SUNDRY NOTICES AND REPORTS ON WELLS

PECOS DISTRICT CONDITIONS OF APPROVAL

OPERATOR'S NAME:	Yates Petroleum Corporation
LEASE NO.:	NM-104706
WELL NAME & NO.:	Renegade BPG Federal #1H
SURFACE HOLE FOOTAGE:	660' FNL & 330' FWL
BOTTOM HOLE FOOTAGE	660' FNL & 2310' FWL
SHL LOCATION:	Section 18, T. 26 S., R. 35 E., NMPM
BHL LOCATION:	Section 17, T. 26 S., R. 35 E., NMPM
	Lea County, New Mexico

Fresh Water Reservior

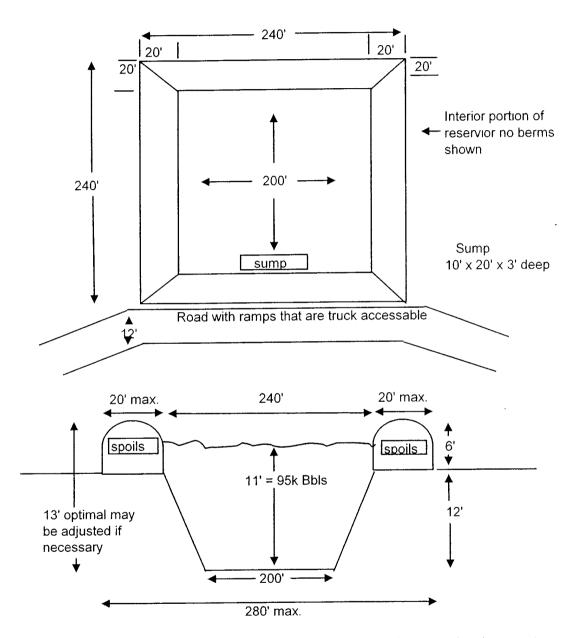
Spoil piles= 3 sides will normally be narrow and the fourth side will include the road and access to the sump.

Bottom Slope= make sure the bottom always slopes to the sump.

Top Edge= Make sure top levels are shot in to ensure adequate Free Board (2')

Road & Ramps = Must be capable of handeling 2 loaded water trucks.

Figure 1 – Cross Sections and Plans For Typical Road Sections

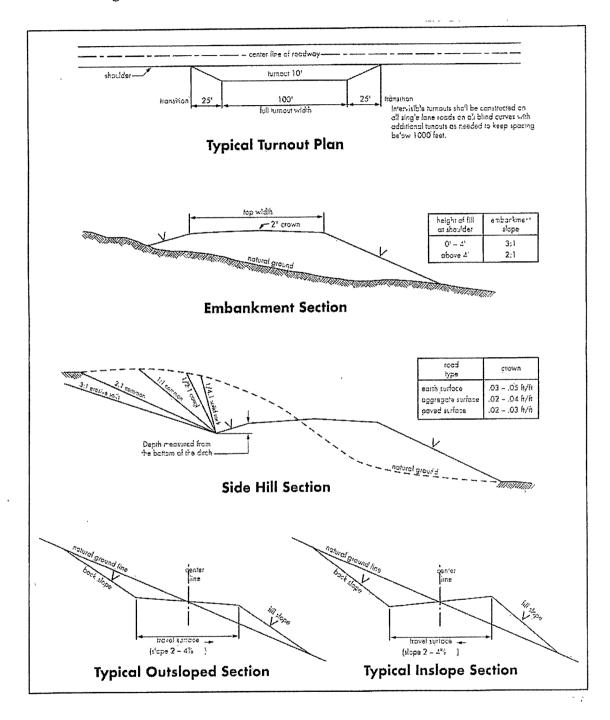
Crowning shall be done on the access road driving surface. The road crown shall have a grade of approximately 2% (i.e., a 1" crown on a 14' wide road). The road shall conform to Figure 1; cross section and plans for typical road construction.
